ADDENDUM NO. 2

PACIFIC HIGH SCHOOL – NEW ADMINISTRATION BUILDING

SAN BERNARDINO CITY UNIFIED SCHOOL DISTRICT

DSA No. 04-119637 File No. 36-H7 RCA Job No. 1-78-28

MAXIMUM EQUIPMENT RACK POPULATION DETAIL

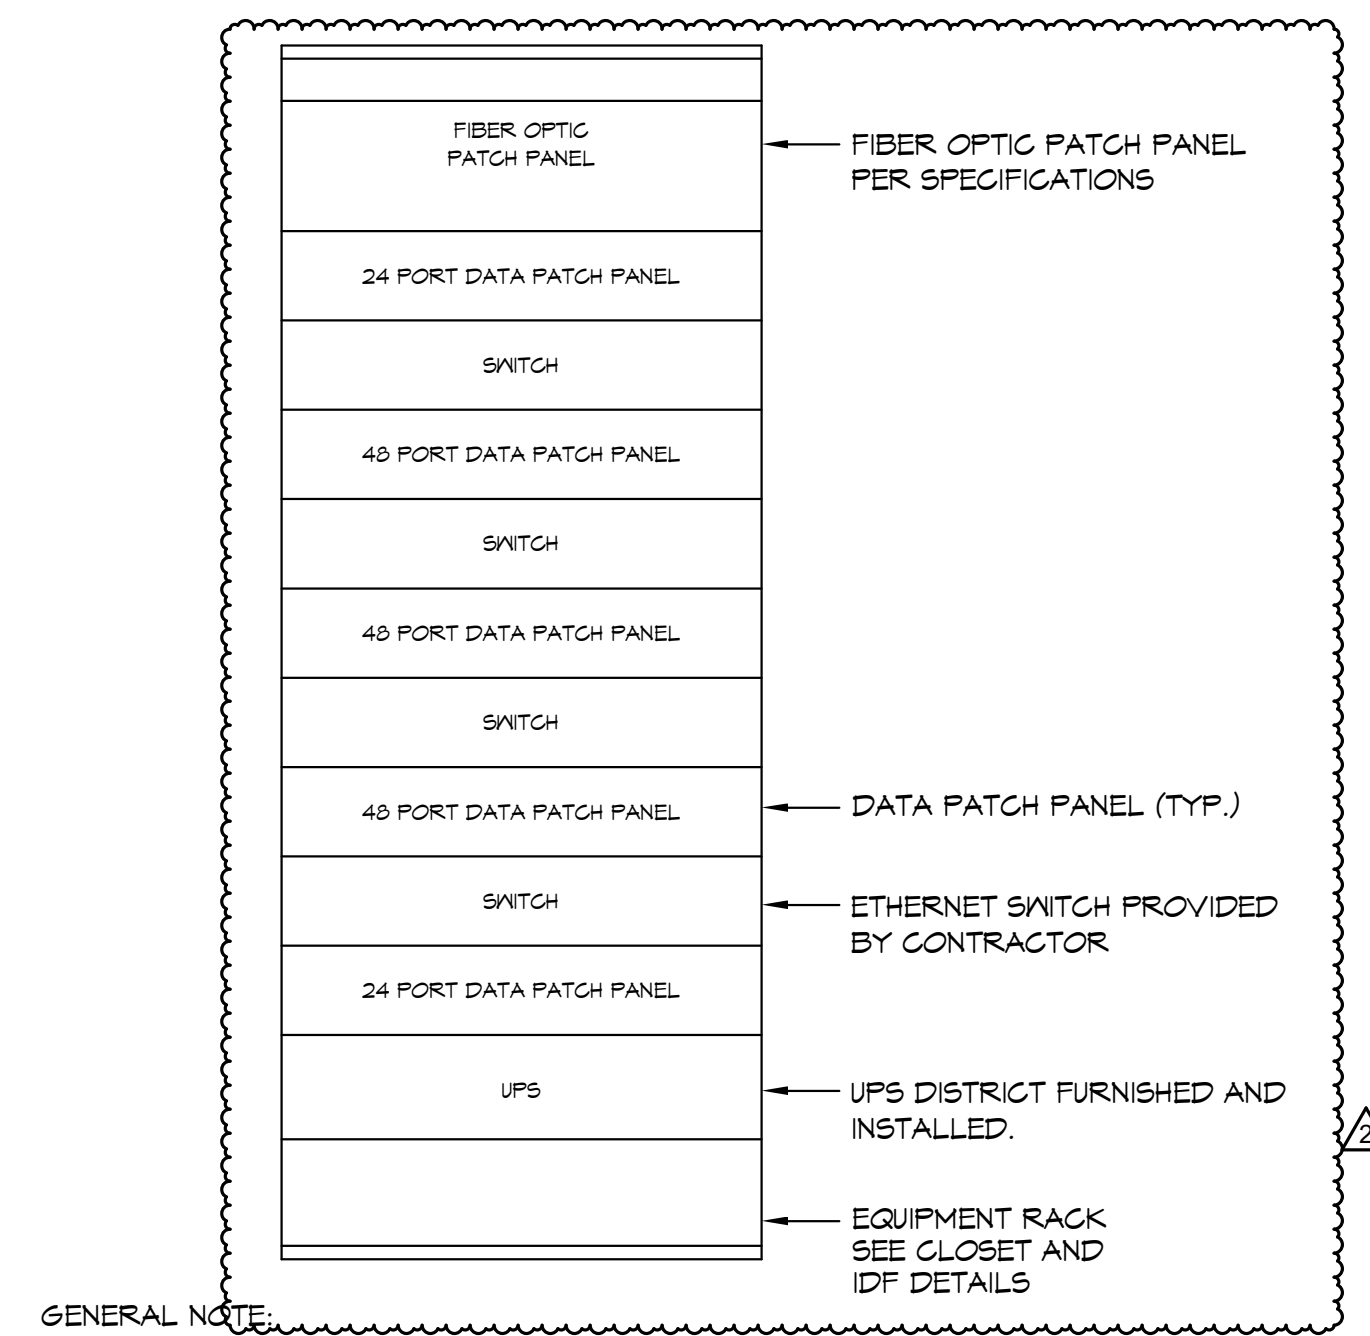
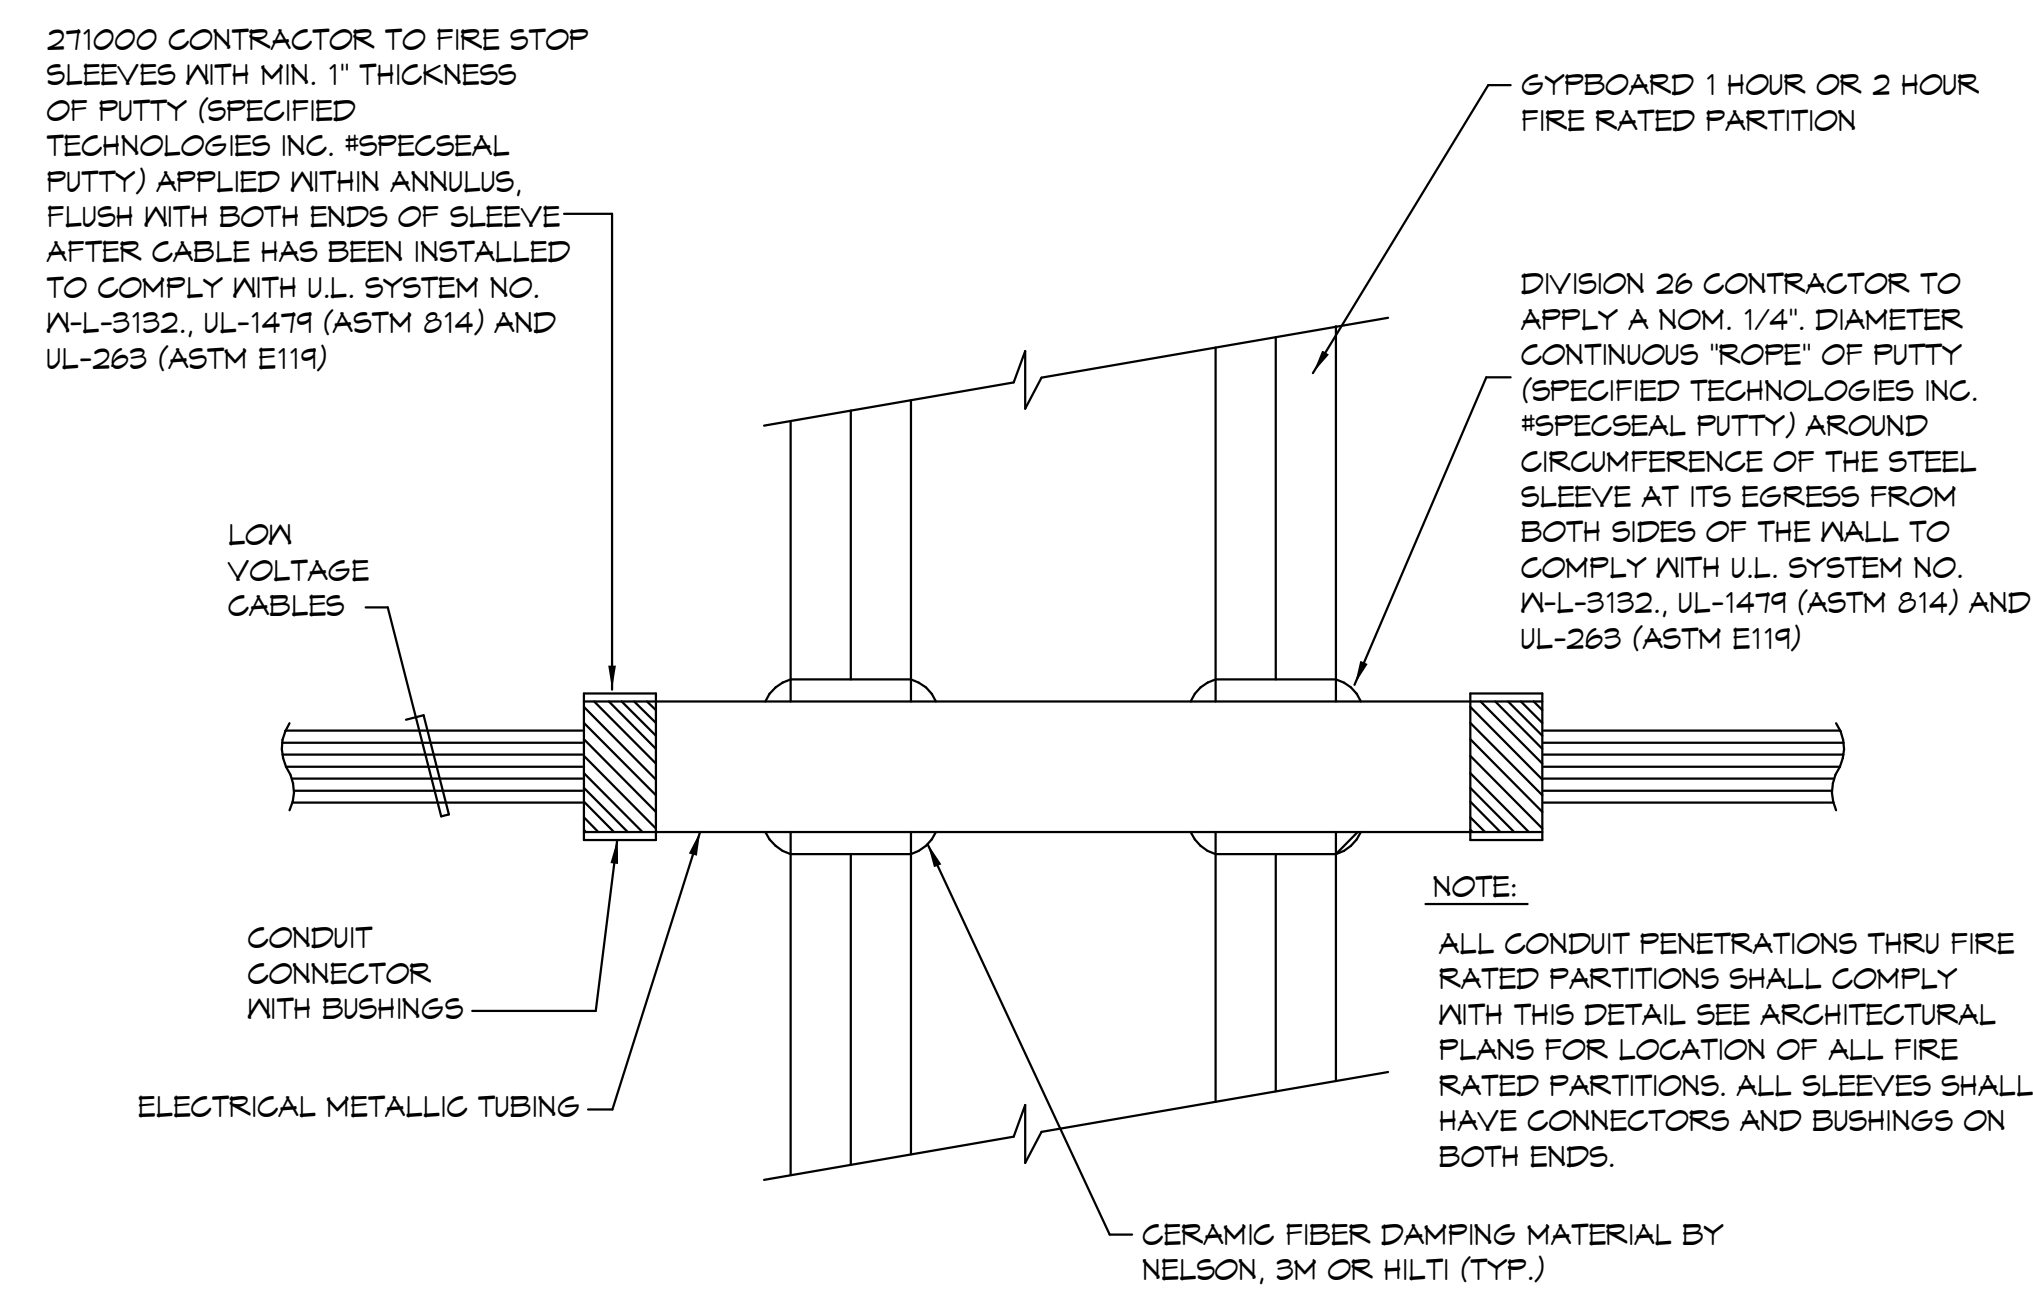
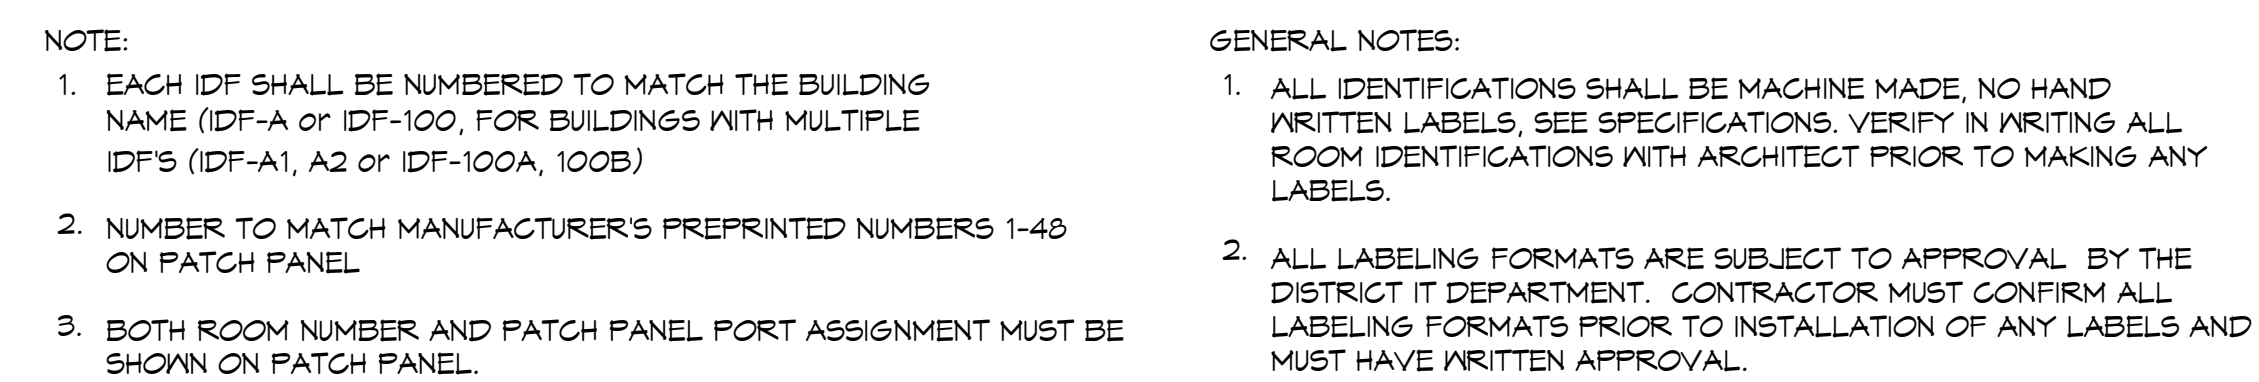
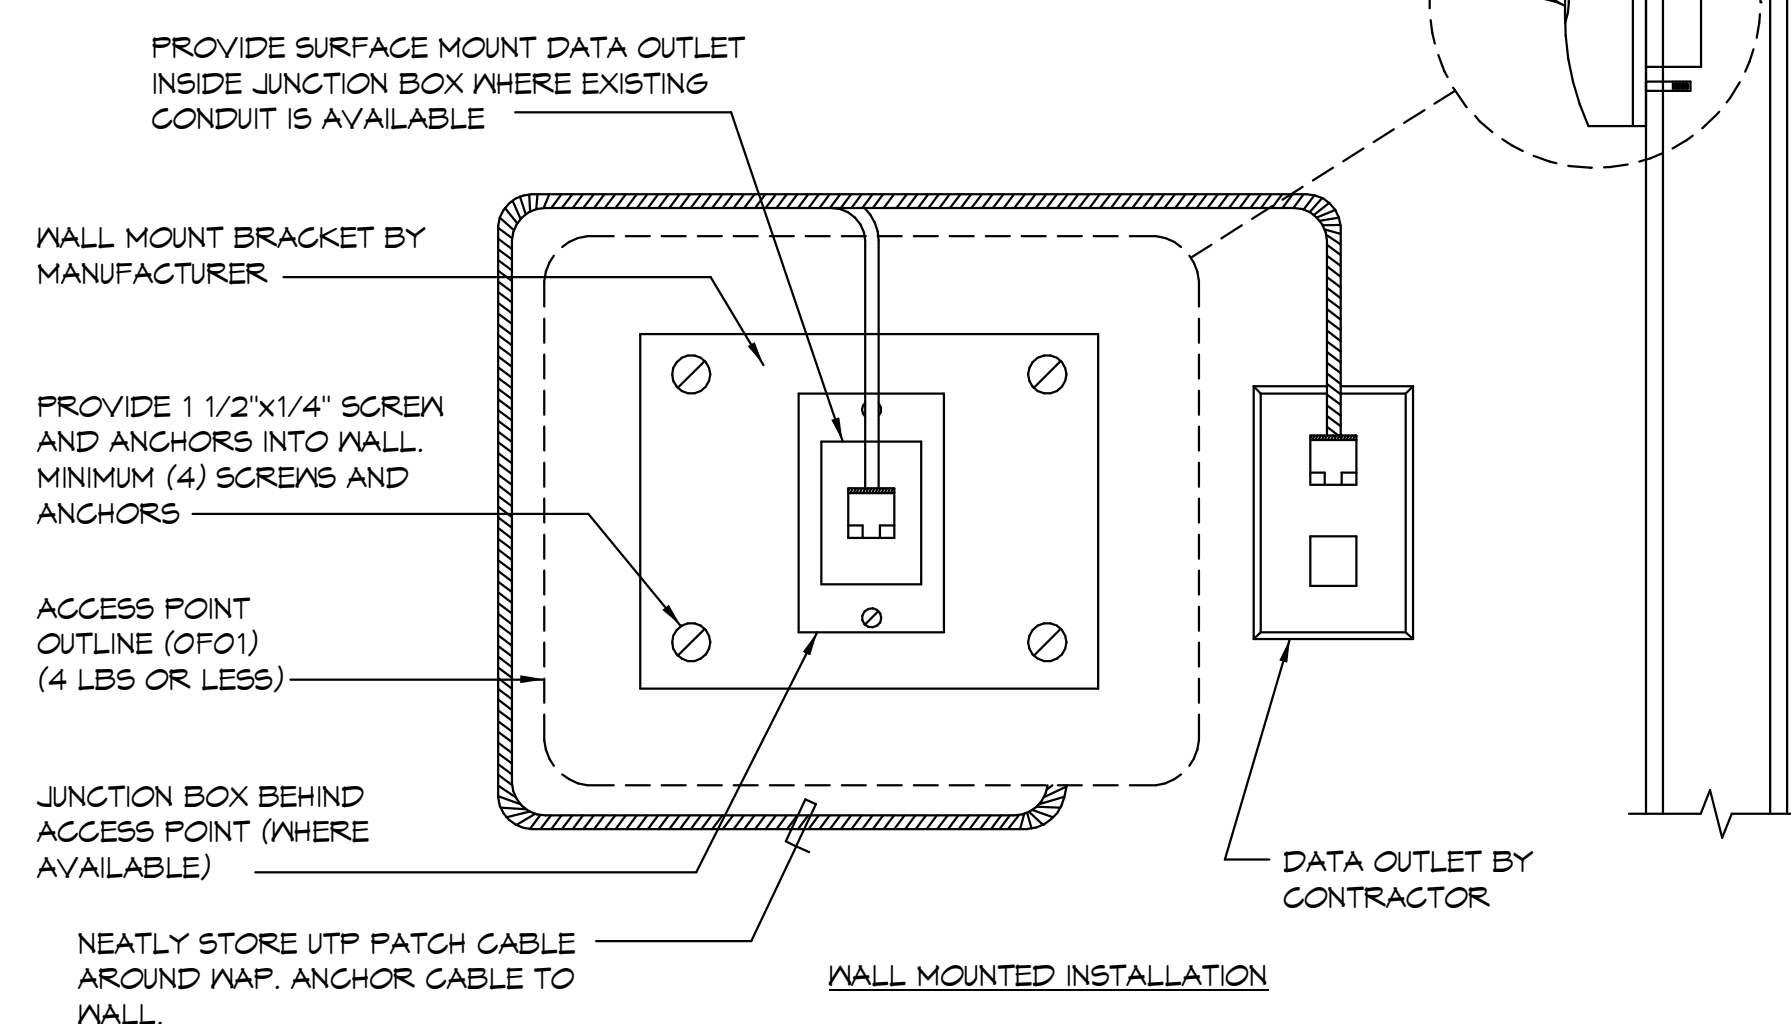
- Item No. 2.24 Reference Sheet E4.4:
2.24.1 Revised Communications details to remove horizontal wire managers and WAPs to be CFCI, per clouded areas of attached revised Sheet E4.4

ROOF PLAN

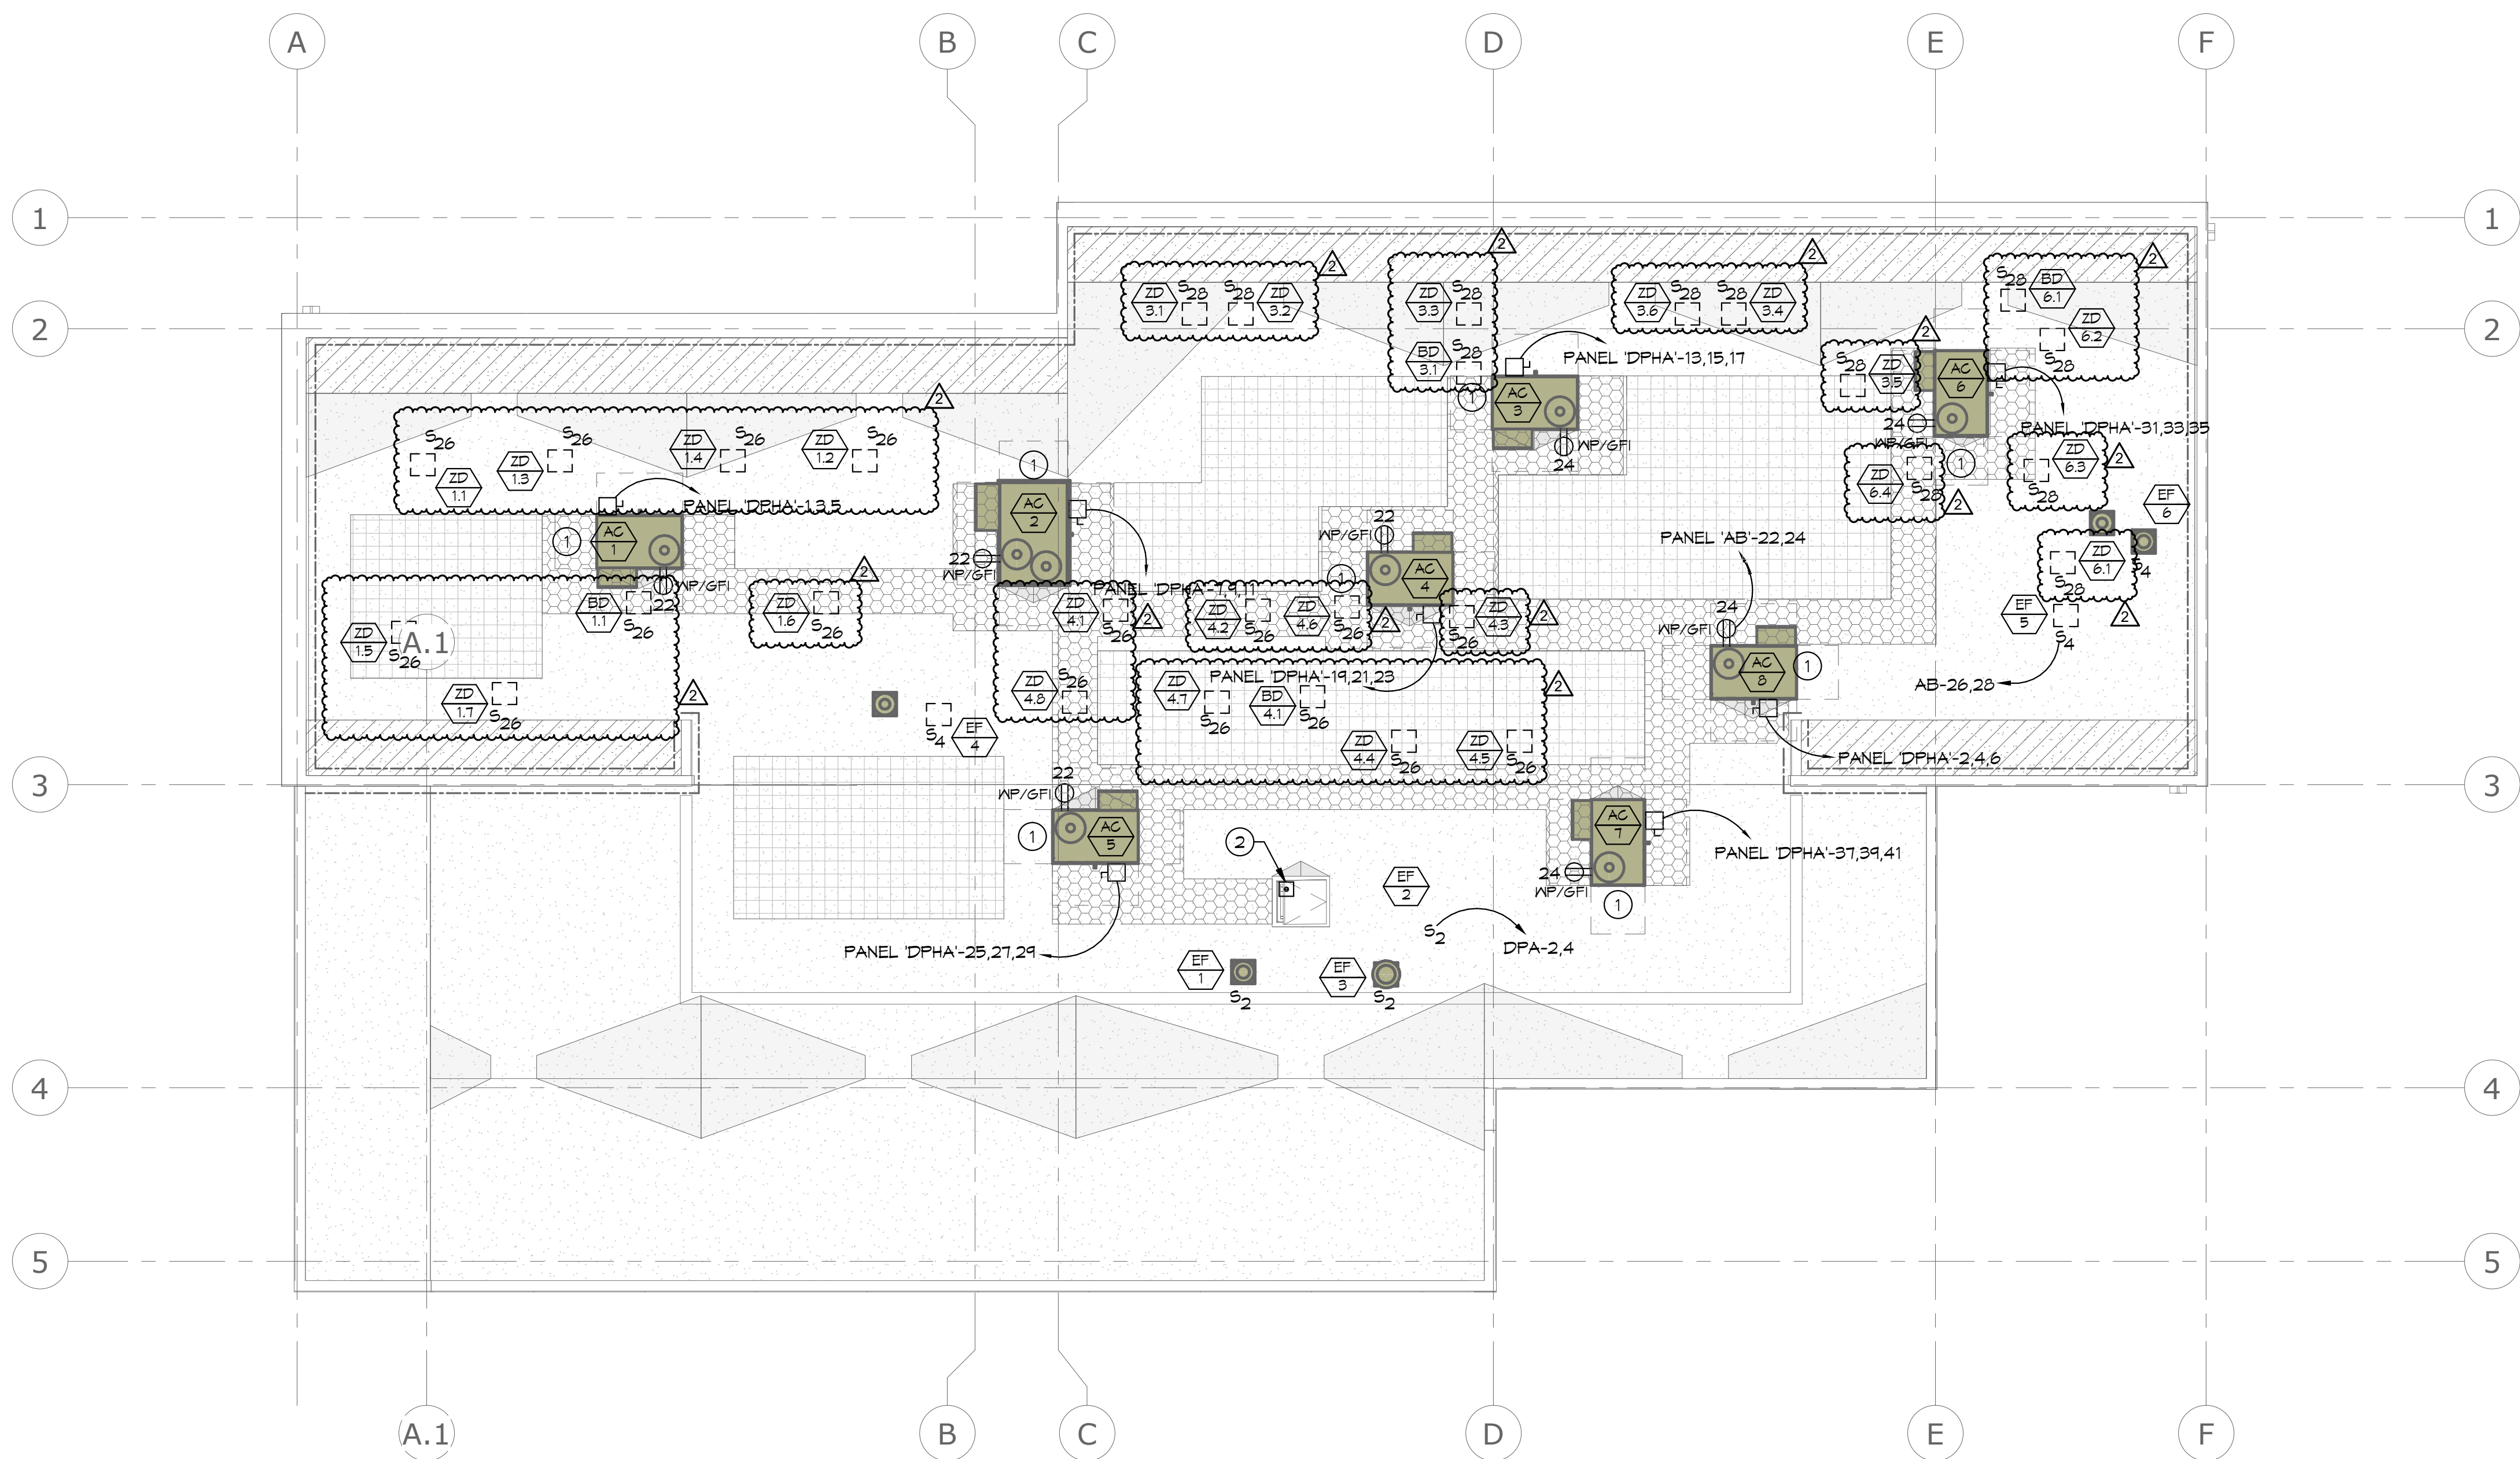
- Item No. 2.25 Reference Sheet E6.1:
2.25.1 Added power connections to all zone/bypass dampers, per clouded areas of attached revised Sheet E6.1
- Item No. 2.26 Reference Sheet E6.2:
